# Access Compliance Report

## Public Rights-of-Way

### (Curb Ramps)

Intersection ID: 21161	Main Street: FOLGER_DR	Cross Street: PROVIDENCE_RD	Location: SW
ADA ID: 53005EB79496	Ramp Type: Directional1	Initial Pass/Fail: Fail	Overall Compliance: No
		Severity Score: 12.5

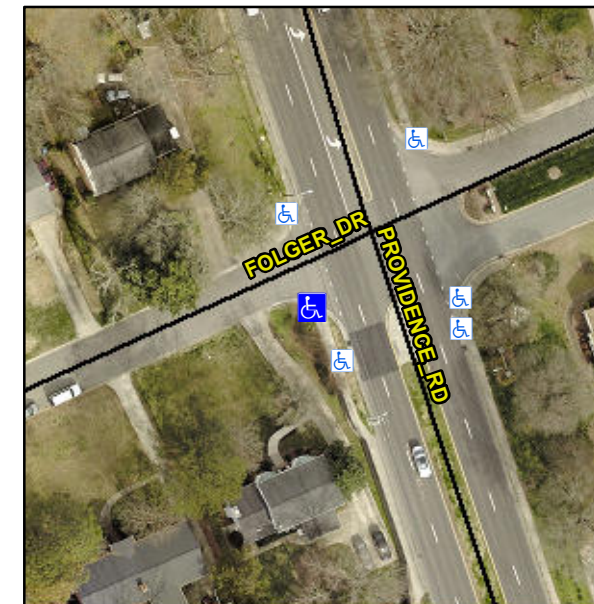
**R304.2.2**

Compliance	Description	Data	Compliance	Description	Data
N/A	Ramp Length (in)	80.0	N/A	Grade Break?	N/A
Yes	Ramp Width (in)	72.0	N/A	Grade Break Slope (%)	0.0
No	Ramp Slope (%)	10.5	N/A	Grade Break XSlope (%)	0.0
Yes	Ramp XSlope (%)	0.7			
N/A	Flare Type LT	N/A	N/A	Flare Type RT	N/A
N/A	Flare Slope LT (%)	N/A	N/A	Flare Slope RT (%)	0.0
N/A	Flare Traversable LT?	N/A	N/A	Flare Traversable RT?	N/A
N/A	Landing Length (in)	0.0	N/A	DWS Provided?	N/A
N/A	Landing Width (in)	0.0	N/A	DWS Contrast?	N/A
N/A	Landing Slope (%)	0.0	N/A	DWS Length (in)	N/A
N/A	Landing X Slope (%)	0.0	N/A	DWS Full Width?	N/A
N/A	Landing Curb? (Y/N)	N/A	N/A	DWS Offset LT (in)	N/A
N/A	Shared Landing?	N/A	N/A	DWS Offset RT (in)	N/A
N/A	Gutter Ponding?	0.0	N/A	Gutter Slope (%)	N/A
N/A	Gutter Lip Ht (in)	0.0	N/A	Gutter X Slope (%)	N/A
N/A	Painted X Walk1?	No		Road Slope (%)	2.8
	X Walk 1 Direction	To NW		Road X Slope (%)	5.4
	X Walk 1 Width (in)	N/A		Clear Space?	N/A

**Remove & Replace Entire Ramp.**
